RIDE THE DUCKS INTERNATIONAL
Fleet Operations & Safety
2320 West Highway 76
Branson MO 65616

Bulletin No. SB-00-7-14
Release Date: 10/15/14
Effective Date: 10/15/14
Supersedes: N/A

Applicable to: All Ducks with
"Louvered" type fire door closures
Total Pages: 1

SERVICE BULLETIN

VIEW OF LOUVER IN THE OPEN POSITION
Note: Missing seals on leading edge of vent louvers.

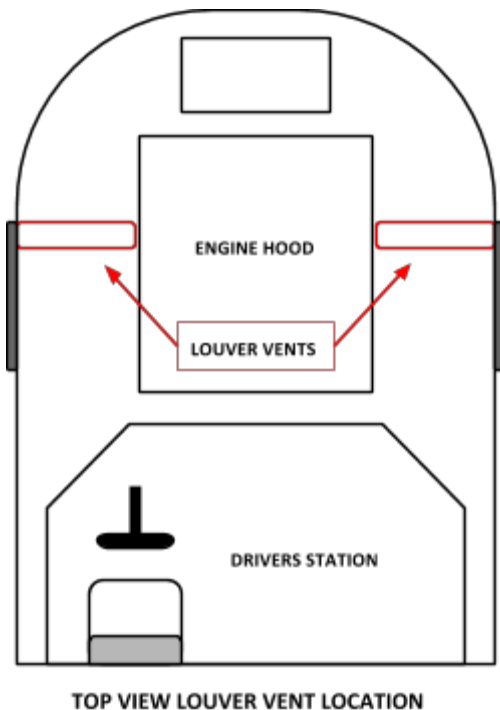
REASON FOR RELEASE: Fire doors are designed to be closed in the event of a fire. The purpose of closing these doors is to restrict airflow that could potentially feed or re-ignite a fire. Due to the continual hot air flowing through these vents and environmental exposure, the seals on the louvers become brittle, break and potentially fall off. This bulletin directs the inspection, proper replacement and how often these seals should be inspected and/or replaced.

VIEW OF LOUVER IN THE CLOSED POSITION
Note: Air can continually flow where seals are missing.

DIRECTIONS: Inspect all "Louvered" type design fire doors. The doors are located on the port and starboard side, forward of the front wheel wells. Inspection may require the removal of the exhaust mufflers on gas powered Ducks to gain access. Inspect each seal and replace if deficient or missing. When louvers are closed there should be no air gaps between louver blades. Inspection of these seals should be done during each periodic / 250 hours vehicle inspection.
